Economic Commission for Europe**Inland Transport Committee****World Forum for Harmonization of Vehicle Regulations****Working Party on Lighting and Light-Signalling****Eightieth session**

Simplification of lighting and light-signalling UN Regulations**Other UN Regulations: UN Regulation No. 53 (Installation of lighting and light-signalling devices for L₃ vehicles)****Proposal for the 03 series of amendments to UN Regulation No. 53 and proposal for amendments to the draft new UN Regulation on Light-Signalling Devices (LSD)****Submitted by the expert from the Special Interest Group for Daytime Running Lamps for L-category vehicles (DRL-L)***

A. Proposal for the 03 series of amendments to UN Regulation No. 53

Model A

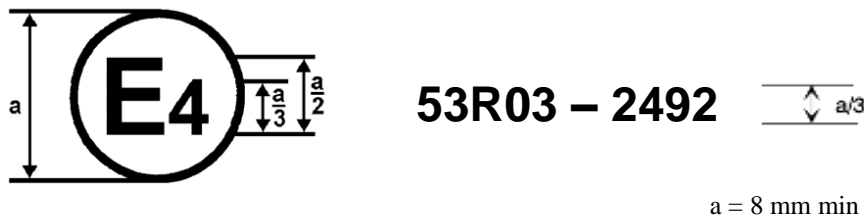
Annex 2, amend to read:

The above approval mark affixed to a motorcycle shows that the vehicle type concerned has, with regard to the installation of lighting and light-signalling devices, been approved in the Netherlands (E 4), pursuant to UN Regulation No. 53, as amended by the 03 series of amendments. The approval number indicates that the approval was granted in accordance with the requirements of UN Regulation No. 53.

Model B

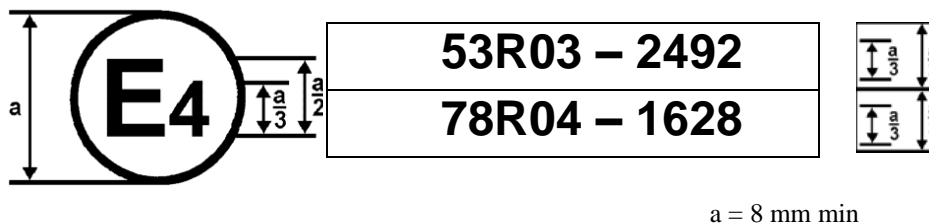
The above approval mark affixed to a motorcycle shows that the vehicle type concerned has been approved in the Netherlands (E 4) pursuant to Regulations Nos. 53 and 78.¹ The approval numbers indicate that, at the dates when the respective approvals were granted, UN Regulation No. 53 included the 03 series of amendments and UN Regulation No. 78 already included the 04 series of amendments. "
